RESPONSE TO SUBMISSIONS

SCEGGS Darlingtonhurst -
Adaptive re-use of Wilkinson
House SSD-19989744

Prepared for
SCEGGS DARLINGTONHURST
27 May 2022

Figure 3 Proposed Street Tree

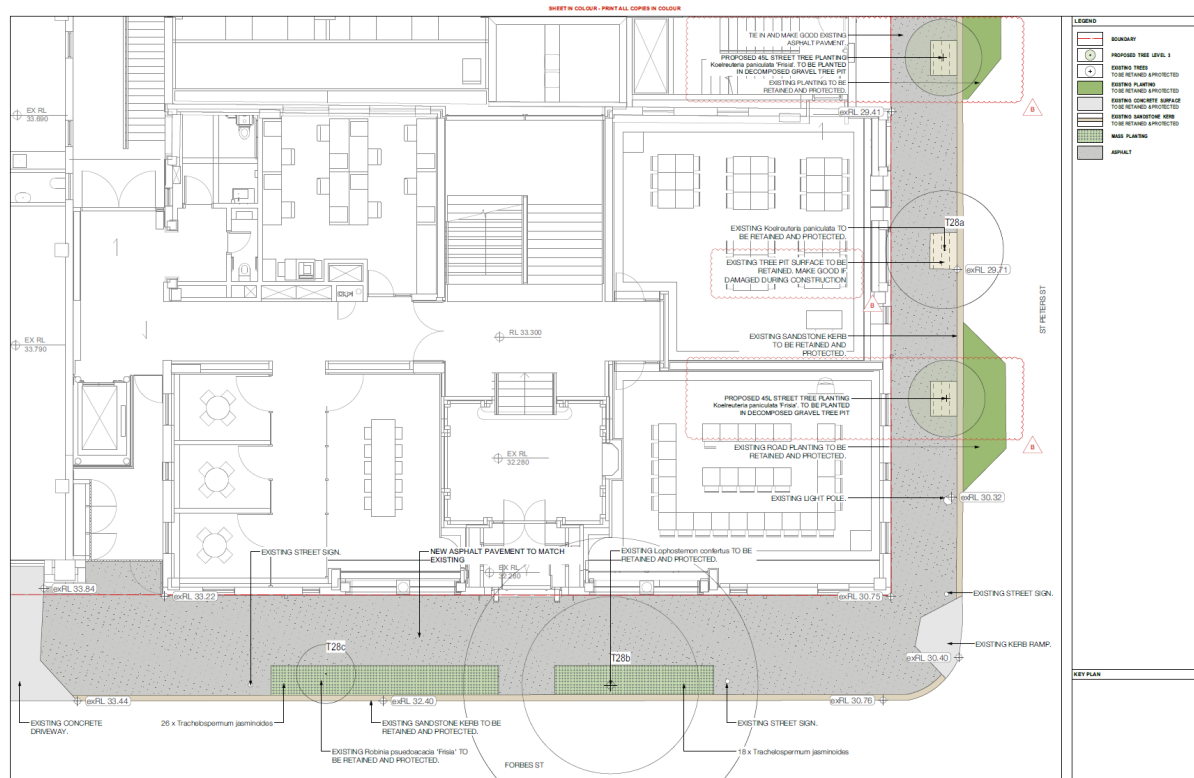
DPE and Council requested that SCEGGs explore alternative landscaping opportunities within or around Wilkinson House. In response to DPE and Council, two additional street trees are proposed along St Peter Street frontage, to enhance greenery in the streetscape.

The project team has explored opportunities to provide additional landscaping on level 3 terrace and the roof area, however it was considered not feasible because of the following reasons:

In lieu of providing additional landscaping within Wilkinson House it is proposed to include two additional street trees along St Peter Street frontage, to enhance greenery in the streetscape (refer to Figure 3).

The tree species proposed is consistent with City of Sydney Street Tree Master Plan, and is also consistent with the existing street trees along St Peter Street.

The proposed street trees are consistent with the Concept SSD Landscape Masterplan as proposed to be modified in the concurrent SSDA Modification Application (SSD-8993-Mod-3)
